TITLE: **EFFIE ESTATES SUBDIVISION, PROPOSED 15 LOTS, 7TH & HEMLOCK, SEQUIM, WA**

**File SUB 22-003 – Effie Estates Preliminary Subdivision
SEPA Mitigation requirements**

CONDITIONS FOR PRELIMINARY PLAT APPROVAL

FIGURE 2
PRELIMINARY PLAT LAYOUT

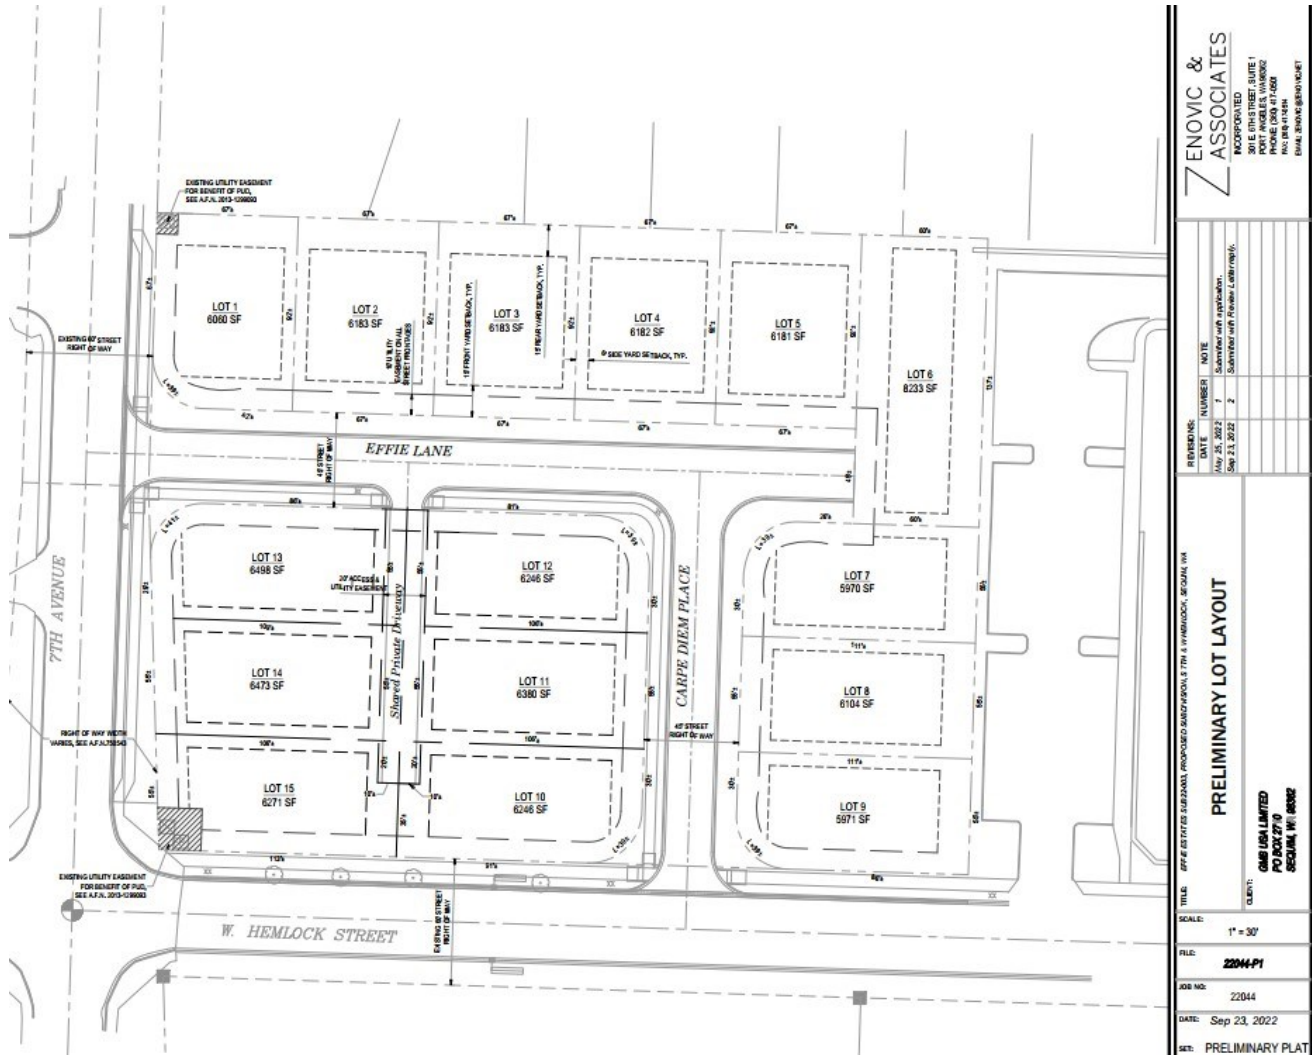
Staff discussion: Each lot will abut a public street. Lots that access off a shared driveway will still abut public streets. Lots 1, 9, 10, and 13-15 will abut S 7th Ave. All other lots (including the lots abutting S 7th Ave) will abut either Effie Lane or Carpe Diem Place.

7. Page C005: Effie Lane Profile: Lot 6 sewer lateral will have less than 2' of cover at the property line. Sewer laterals shall have 5' minimum cover at the property line per the Engineering Standard Figure 6-11, Standard Side Sewer Connection. Please address.

6. Indicate the Emergency Overflow for infiltration trenches. It appears overflow will be sent to lot 6 if the catch basins are blocked or the infiltration trenches reach capacity. Prior to site construction issuance, address how stormwater will be captured in Effie Lane prior to leaving the roadway and entering Lot 6.

1. Show on-lot grading.
2. Slope, grading and wall elevations at the northeast corner of lot 6 shall be accurately shown.
